\_\_\_\_\_  
In the Matter of )  
Boston Edison Company, et al. )  
(Pilgrim Nuclear Generating Station, )  
Unit 2) )  
\_\_\_\_\_)

TESTIMONY OF PHILIP B. HERR ON PILGRIM 2  
POPULATION DENSITY AND OTHER SITE  
CHARACTERISTICS, SUBMITTED BY INTERVENOR  
COMMONWEALTH OF MASSACHUSETTS  
IN SUPPORT OF ITS CONTENTION NO. 12

Commonwealth Contention 12:  
Neither Applicants Nor Staff Have  
Adequately Considered the Alternative  
of Locating the Proposed Plant at a  
Site More Suitable from a Population  
Density and Environmental Standpoint.

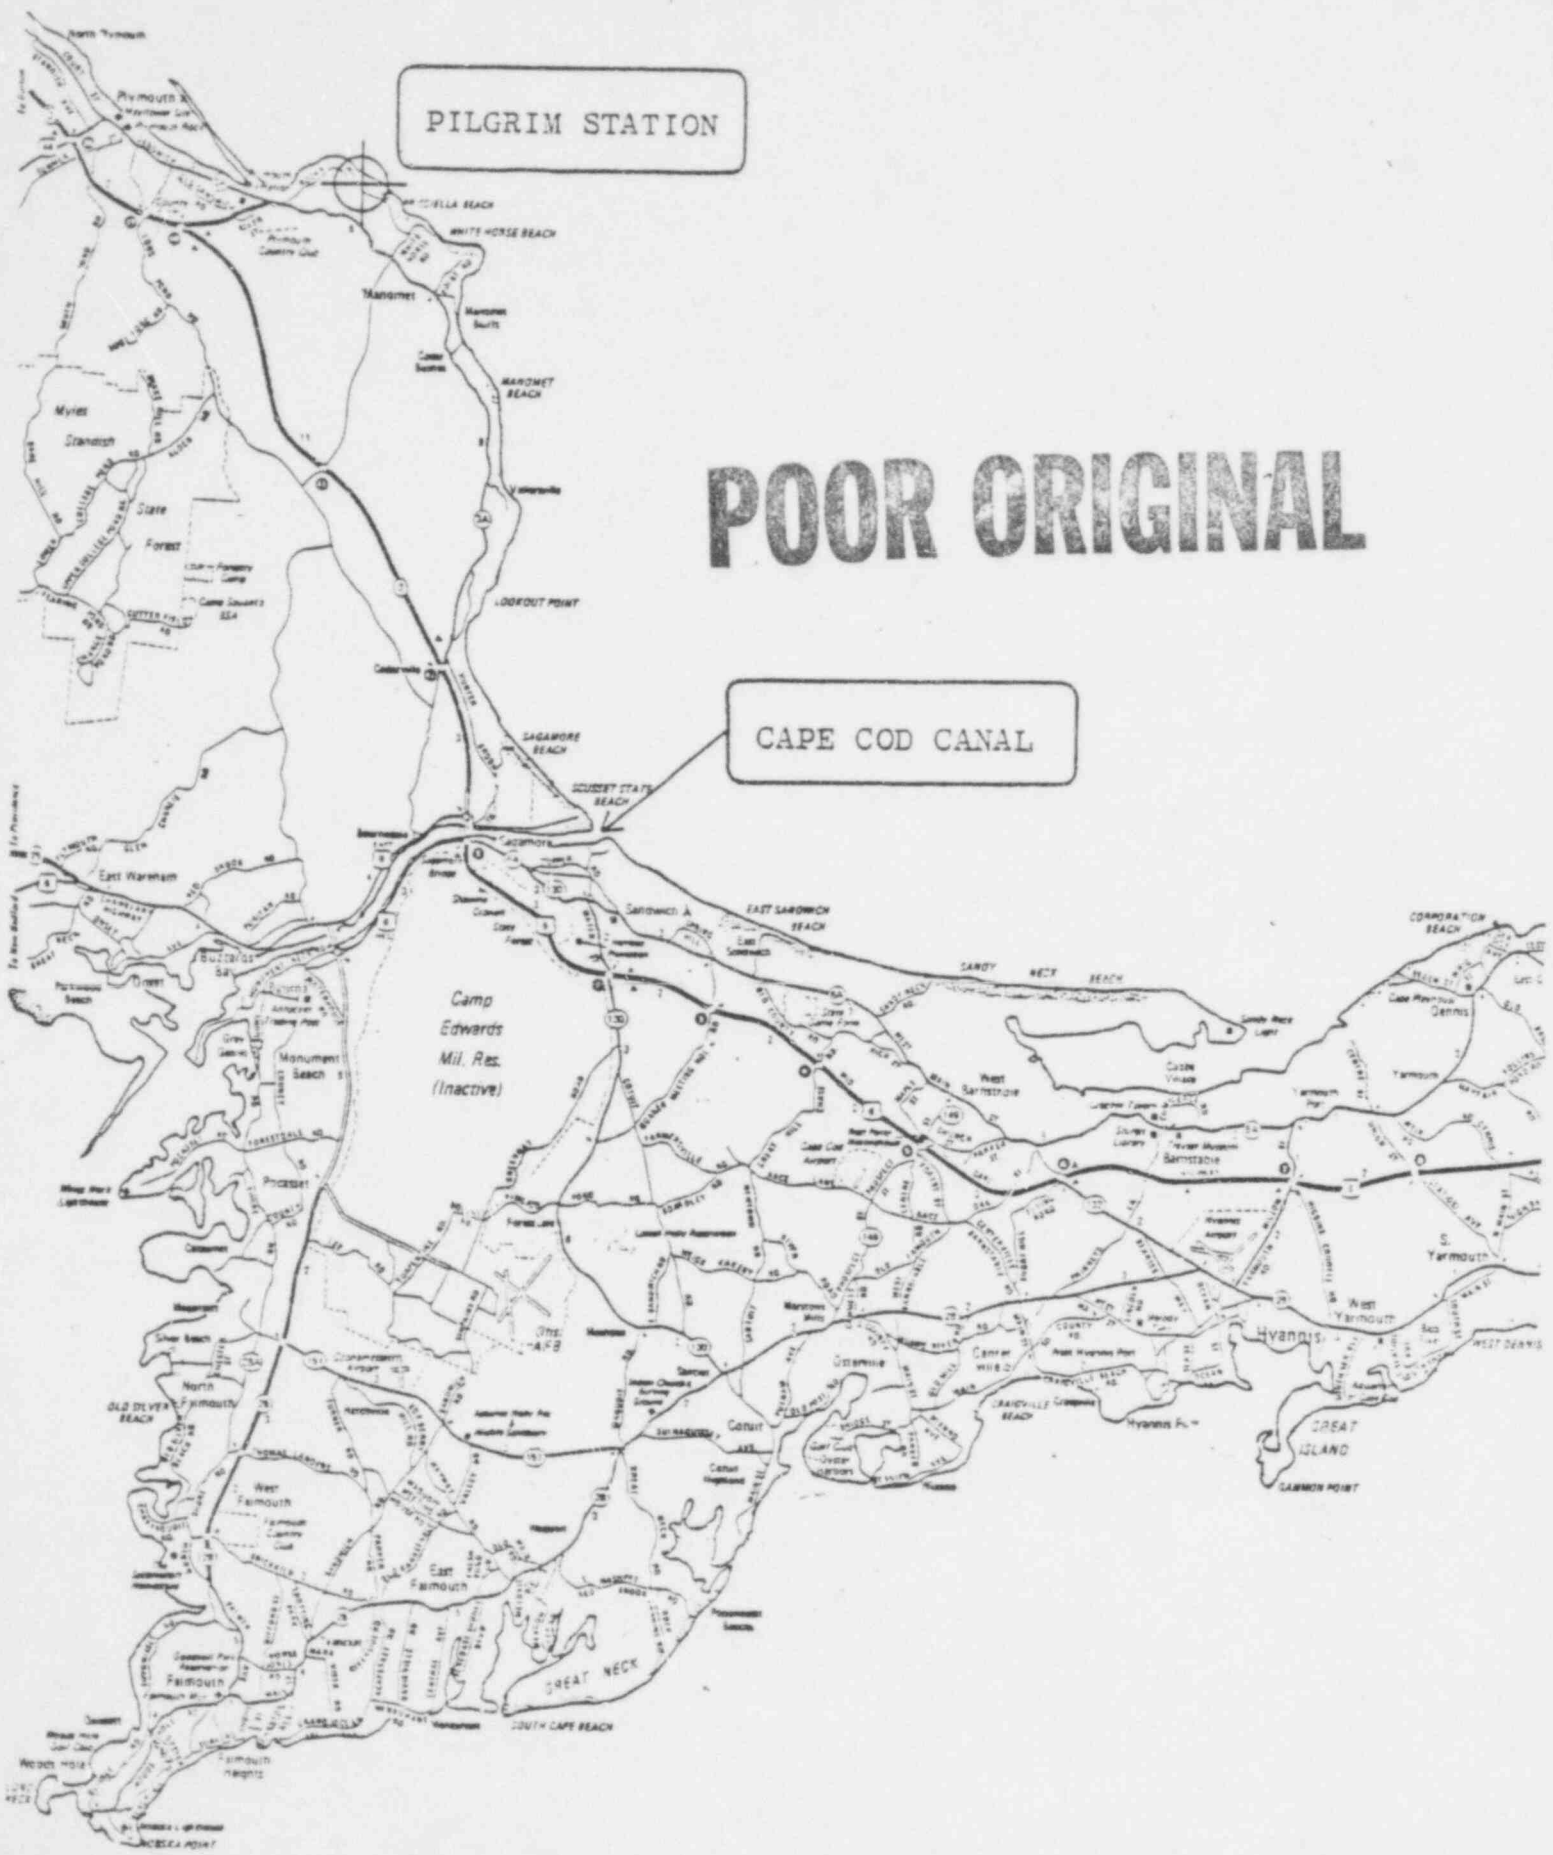
Egress configurations and limitations makes the southeast situation in the event of a major accident even more serious than population density suggest. As Figures 4 and 5 illustrate, there are special site circumstances regarding evacuation routes from the vicinity of Rocky Point, especially for population south or southwest of that site. Because of the presence of the Myles Standish State Forest and a vast largely undeveloped area, movement southwesterly through that area is possible only over a rudimentary maze of narrow, winding two-lane roads, many unpaved and discontinuous, all of them poorly marked.

Evacuation from Cape Cod, whether voluntary or mandatory, would be via a road system notorious for its present deficiencies. Again, see Figure 5. For a variety of jurisdictional and policy reasons, those deficiencies are likely to only slowly be removed. Most obvious is the limitation that all egressing traffic must use the two Canal bridges of four narrow lanes each.

# Figure 6 SAGAMORE BRIDGE CLOSED: EMERGENCY VOLUMES & CAPACITIES

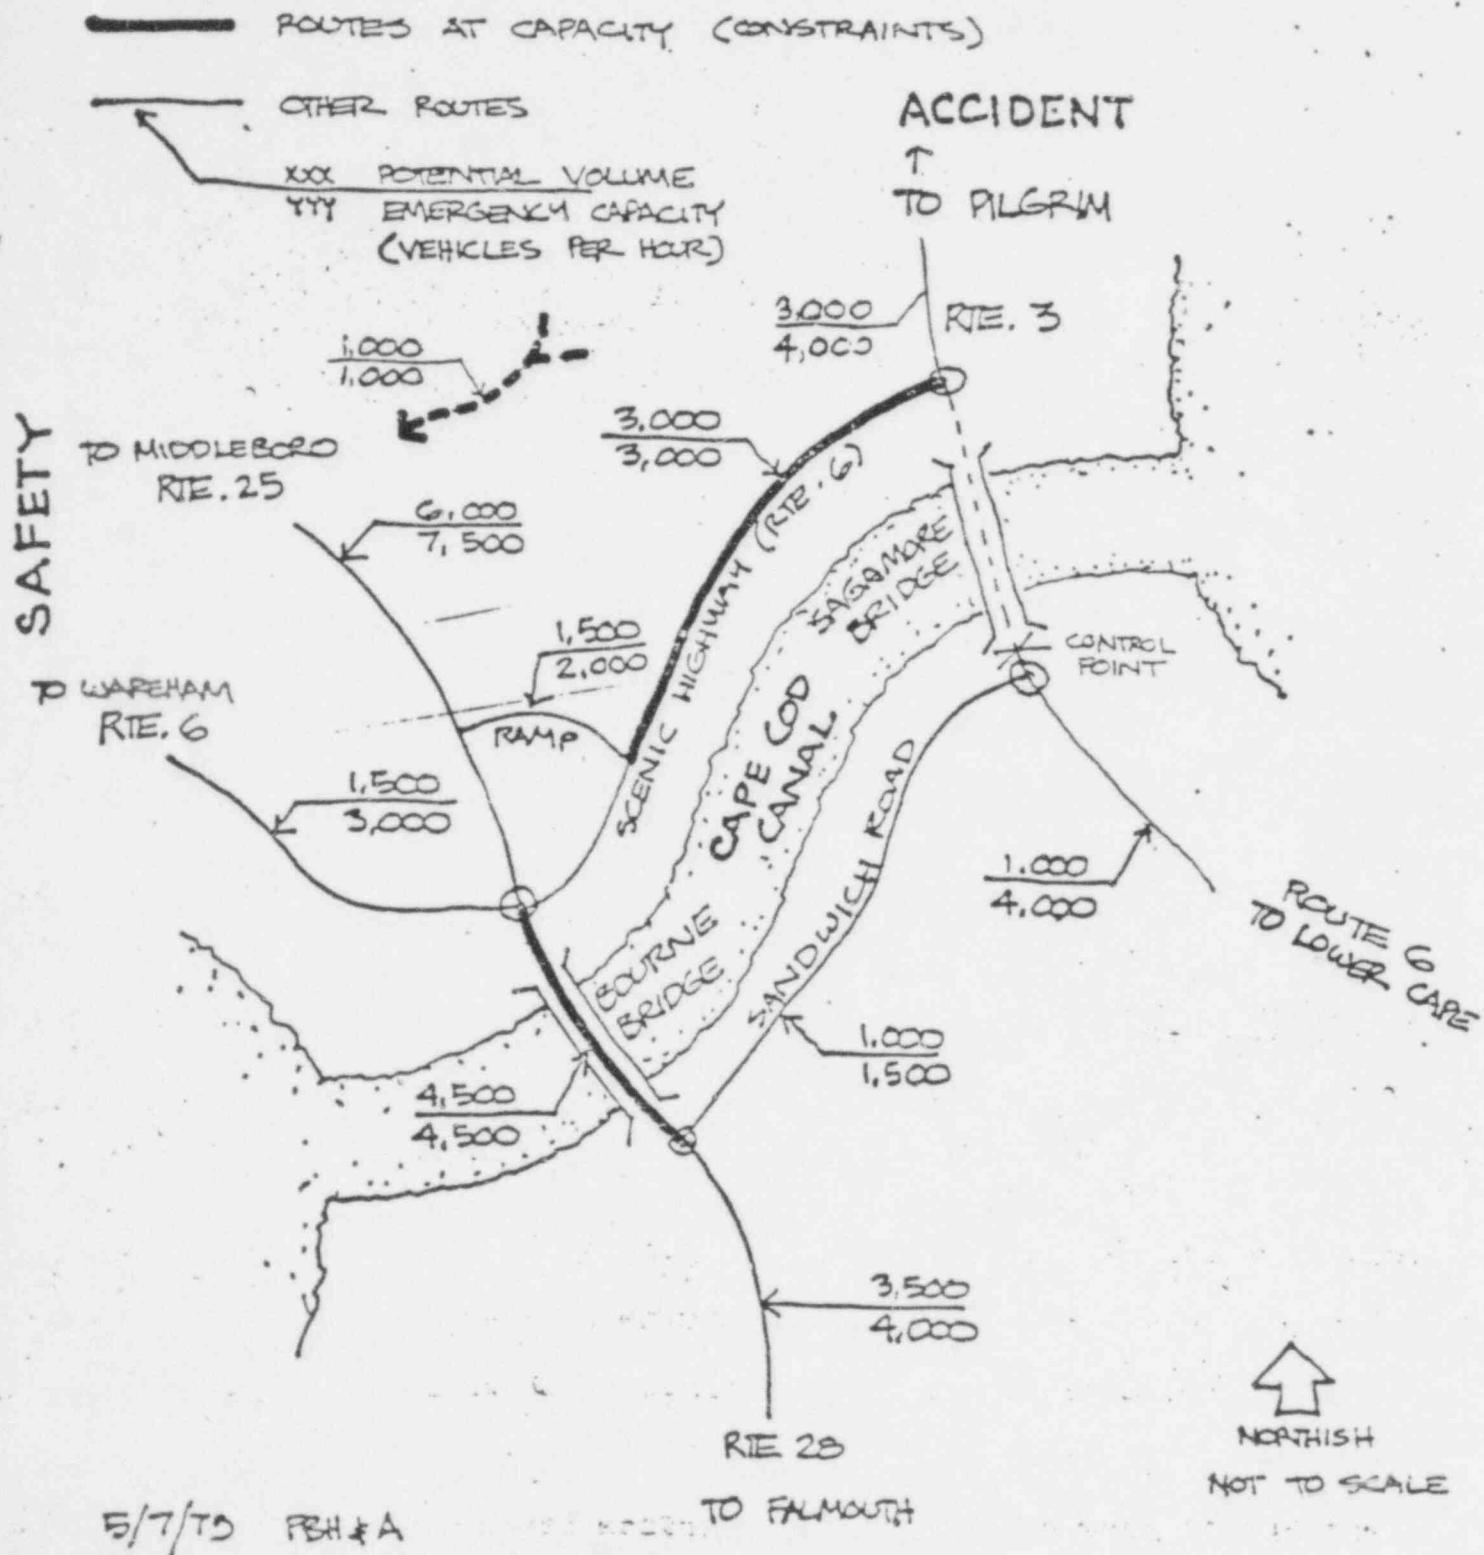
evacuating 12,000 vehicles over the Scenic Highway plus the back road maze. If two lanes of the Scenic Highway (which varies from 2 to 4 lanes) were reserved for westbound traffic and the Sagamore Bridge were closed to traffic leaving the Cape (in order to reserve Scenic Highway capacity for evacuees), the Scenic Highway would provide capacity for 3,000 vehicles per hour from the ten-mile zone. Another 1,000 vehicles per hour might use back roads. That means a three-hour minimum evacuation time, assuming no breakdowns, expert guidance, and good weather. This evacuation scenario is illustrated by Figure 6.

# Figure 7 ROUTE 3 NORTH CLOSED EMERGENCY VOLUMES & CAPACITIES

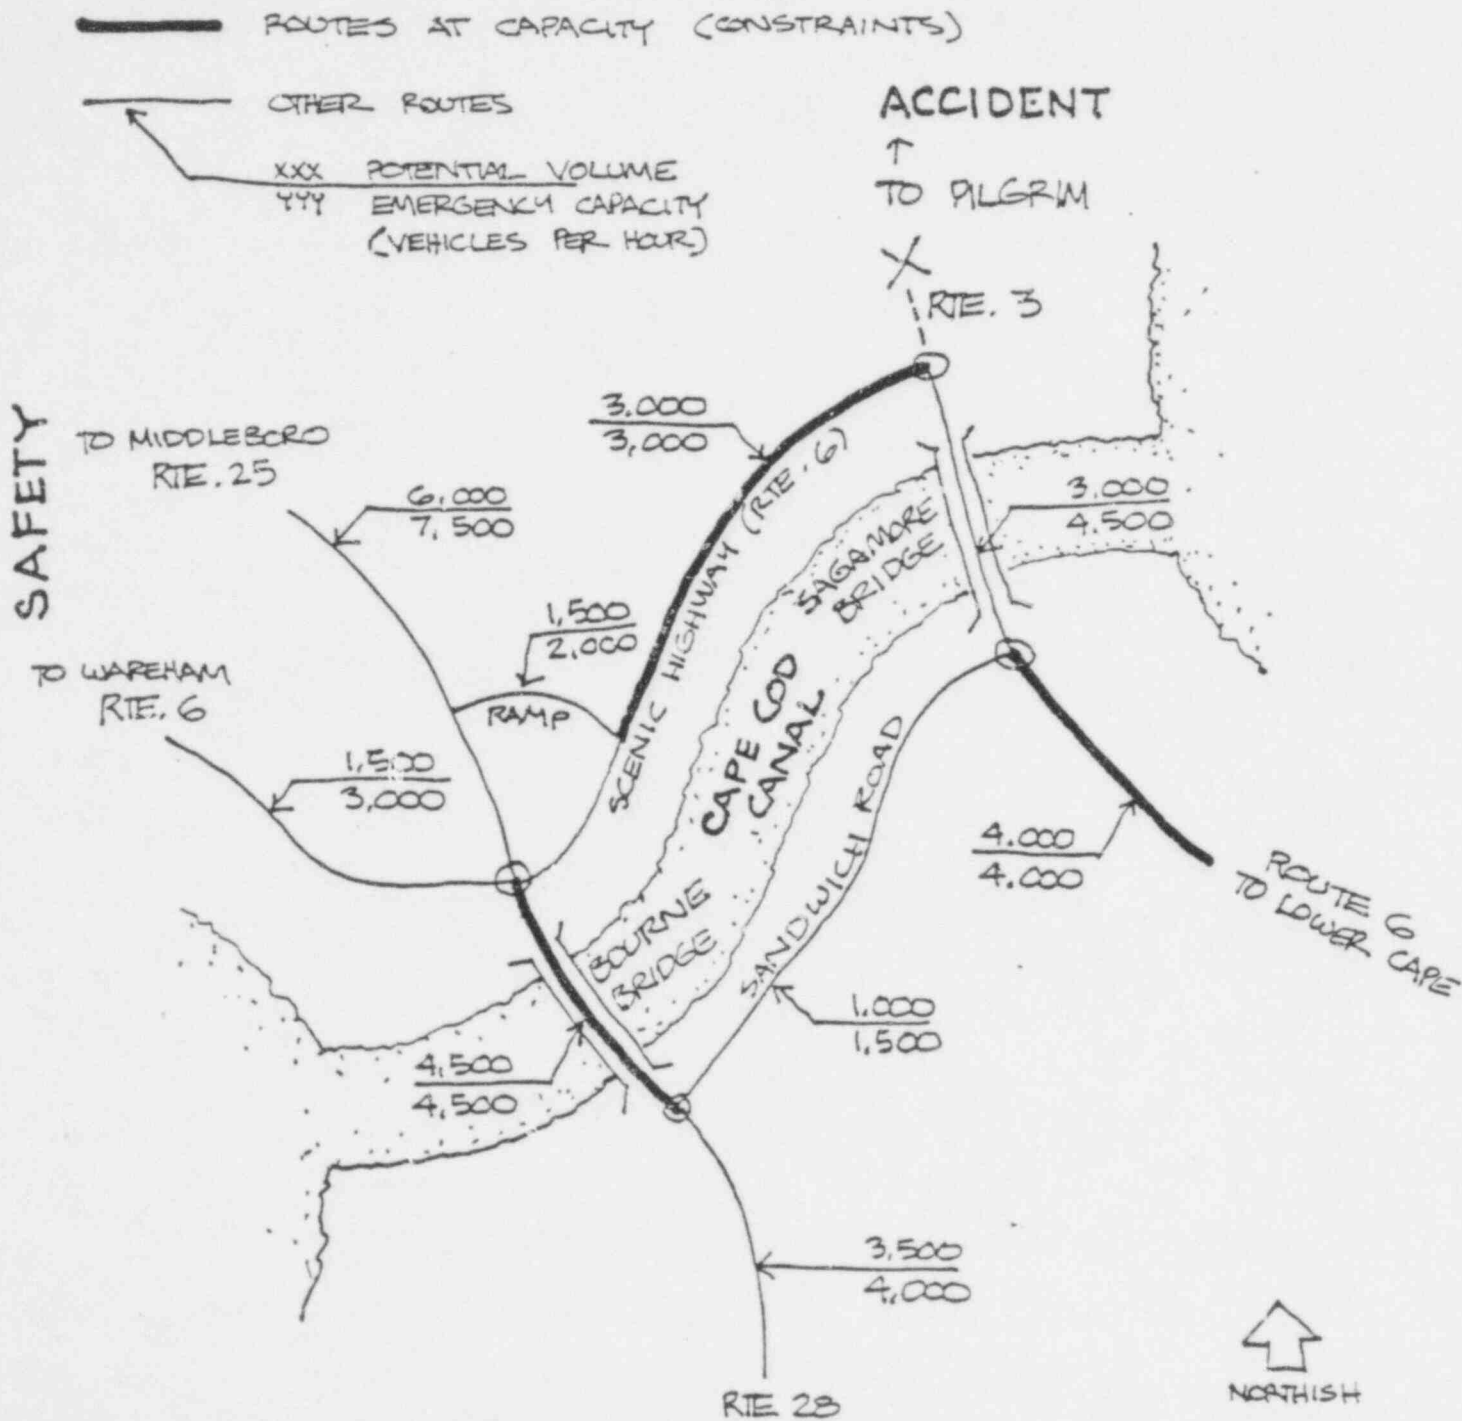
network within six hours, most likely causing thereafter the closure of the Scenic Highway and either or both of the Cape Cod Canal bridges.<sup>12/</sup> See Figure 7.

Figure 8 ROCKY POINT SOUTHEAST

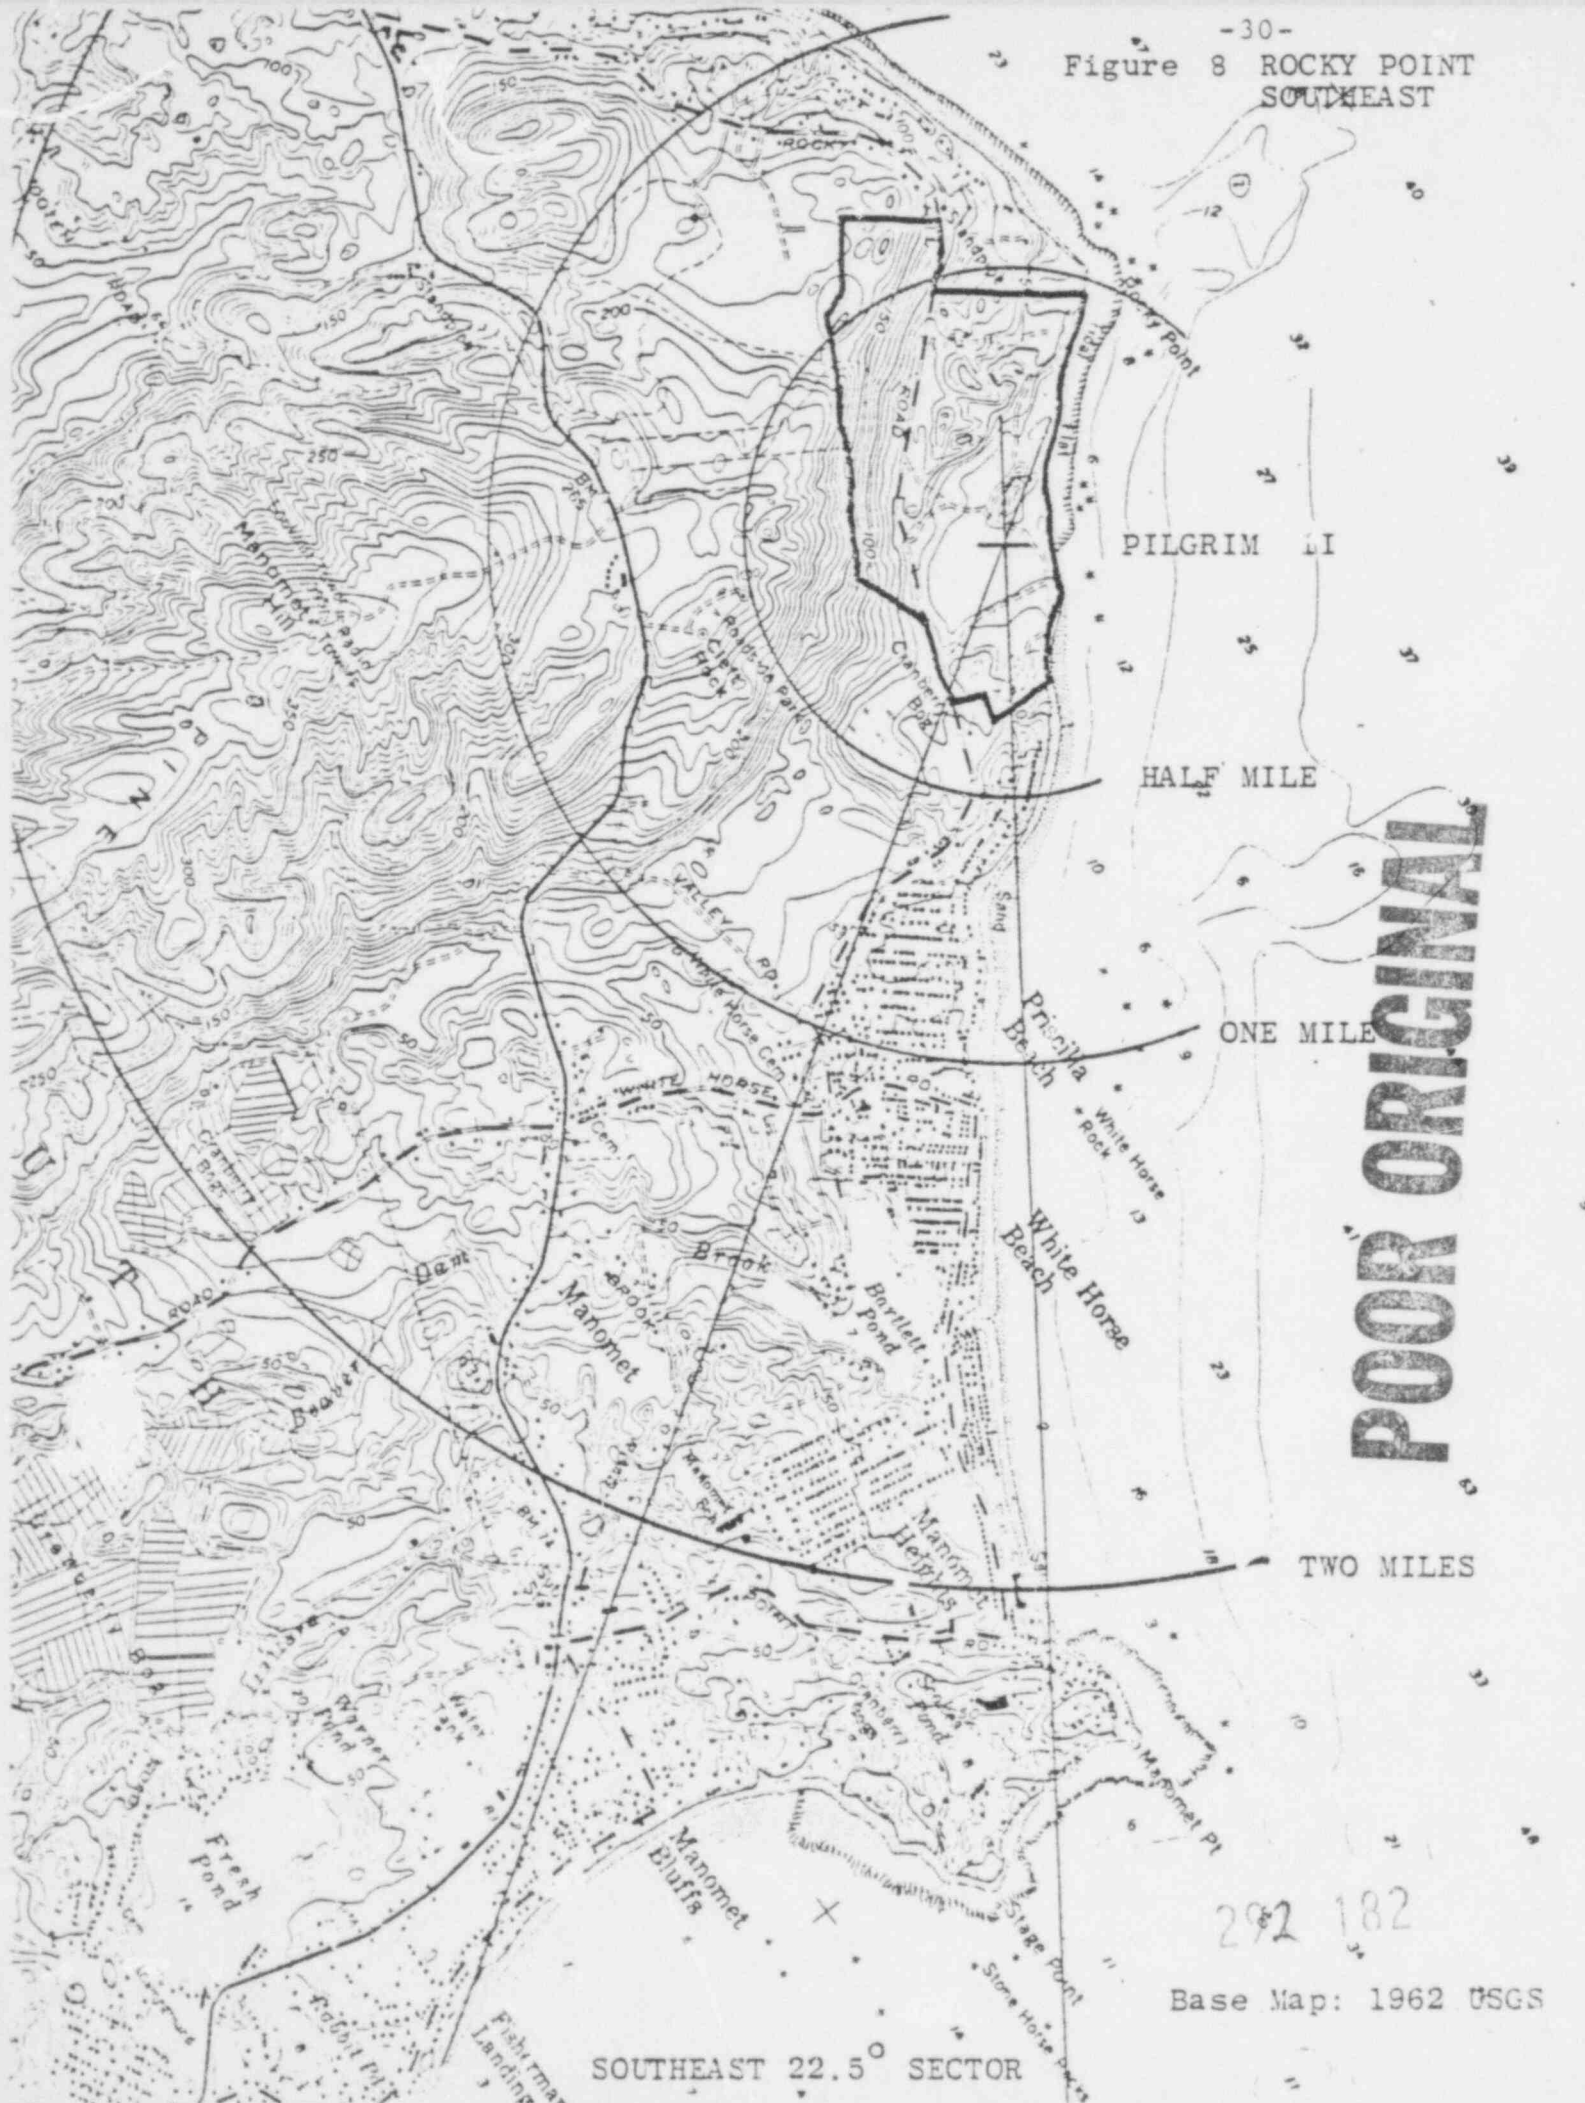
As with Cape Cod, the configuration of land, water and roads limit emergency evacuation measures. Based on PSAR data, Priscilla Beach, White Horse Beach and Manomet Heights have a summer resident population of some 7,000 persons; all are within a narrow arc and less than two miles from the Rocky Point site (see Figure 8). Only two narrow two-lane roads provide that population
